GROUP	MODEL
ELE	2023MY Sportage (NQ5a) w/ AVNT Head Unit
NUMBER	DATE
355	October 2024

TECHNICAL SERVICE BULLETIN

AVNT COAXIAL CABLE REPLACEMENT

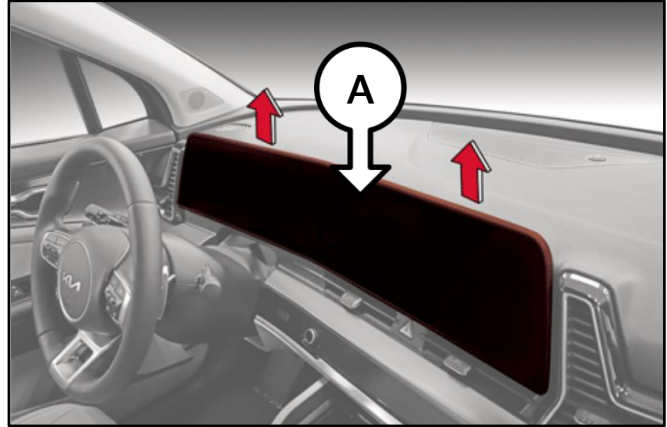
This bulletin provides the procedure to replace the Audio Video Navigation Telematics (AVNT) head unit coaxial cable on some 2023MY Sportage (NQ5a) vehicles produced from August 5, 2021 through May 25, 2023. The affected vehicles may experience the AVNT screen flickering 'ON/OFF' due to an intermittent contact of the coaxial cable connector with the AVNT head unit. Follow the procedure outlined in this publication to replace the AVNT head unit coaxial cable on the applicable vehicle.

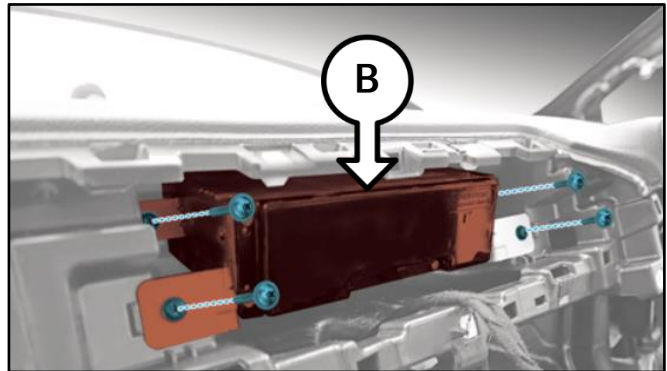
1. Remove the Instrument Cluster (A) by referring to "Body Electrical System → Indicators and Gauges → Cluster → Removal and Installation → [Option Type]" in the applicable Shop Manual on KGIS.

2. Remove the AVNT head unit (B) by loosening the four (4) retaining screws.

Place a clean cloth/fender liner under the AVNT head unit to prevent any scratching/damage to the head unit surface.

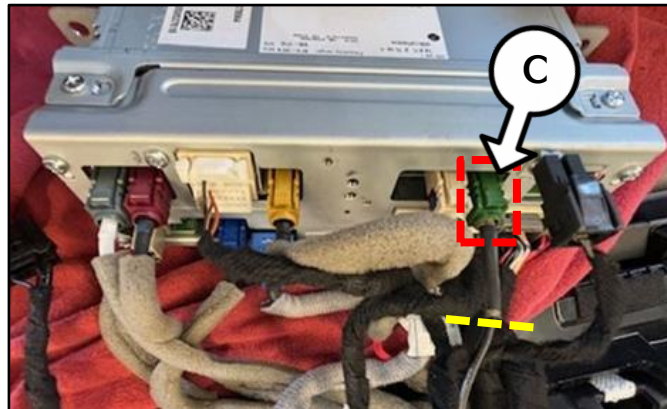
- 3a. Disconnect the coaxial cable connector (C).
- 3b. Using a wiring cutter, cut-off the end of the removed coaxial cable and connector where shown and dispose of the connector end.

Note: Only the coaxial cable connector (C) needs to be disconnected.

M11-M

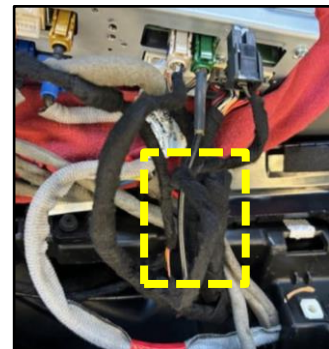
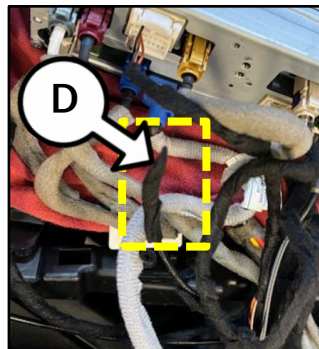
- 4a. Wrap the cut end of coaxial cable (D) using Tesa® tape.
- 4b. Secure the coaxial cable (D), to the harness, as shown.

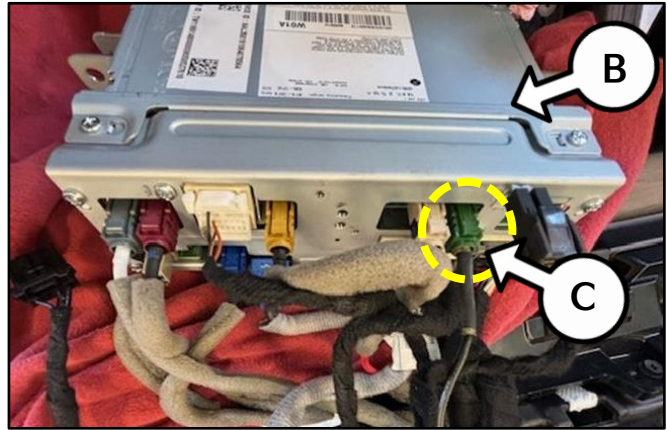
5. Connect the 'new' coaxial cable connector (C) to the back of the AVNT head unit (B).

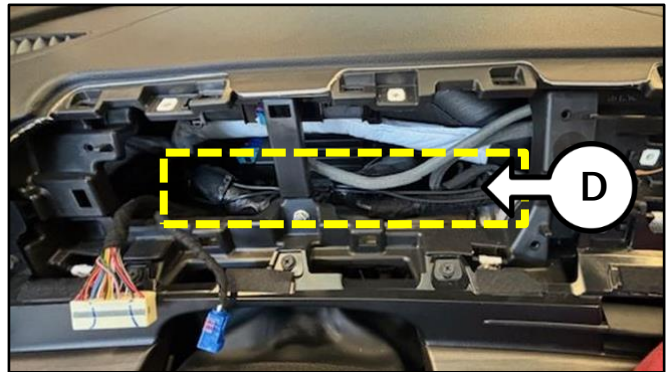
- 6a. Route the 'new' coaxial cable (D) along the main harness inside the dash area, as shown.

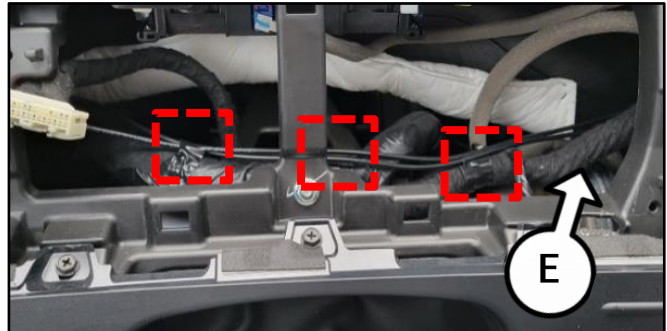
- 6b. Secure the new coaxial cable (D) to the main harness (E) with three (3) zip-ties in the locations shown.

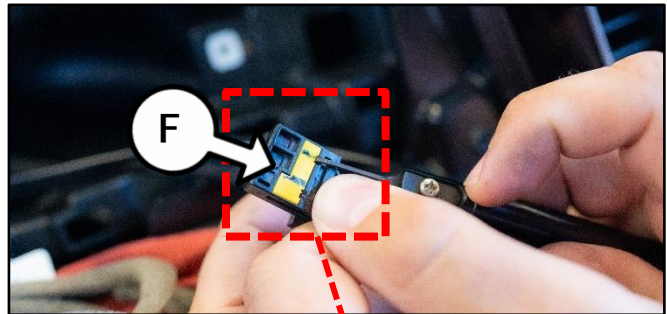
7. Using a pin removal tool, unlock the navigation monitor connector (M22) (F) yellow tab.

- 8. Using a pin removal tool, separate the coaxial pin 5 (G) from the connector (F).

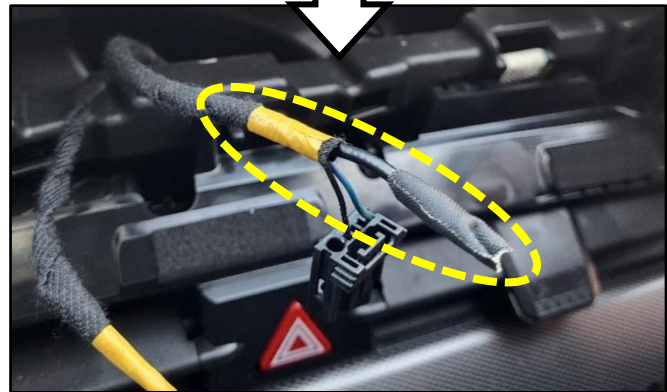
Insert the pin removal tool in the orientation shown.

- 9. Using Tesa® tape, wrap the exposed pin as shown.

Note: The pin does not need to be cut.

- 10a. Insert the 'new' coaxial cable pin (G) into pin 5 of the navigation monitor connector (M22) (F).

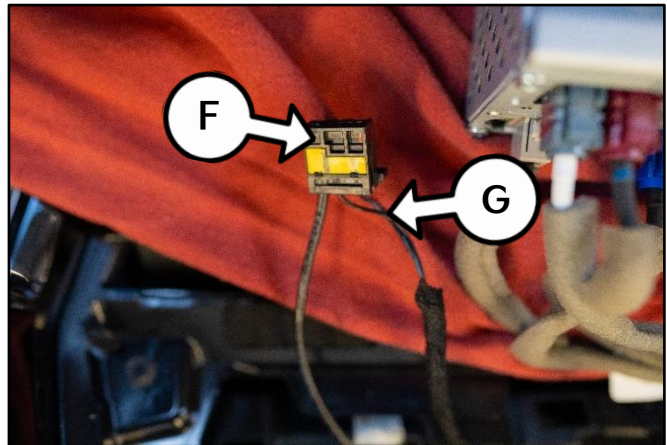
- 10b. Engage the locking tab.

- 11. Reinstall all removed parts in reverse order of removal.
- 12. Confirm normal operation.
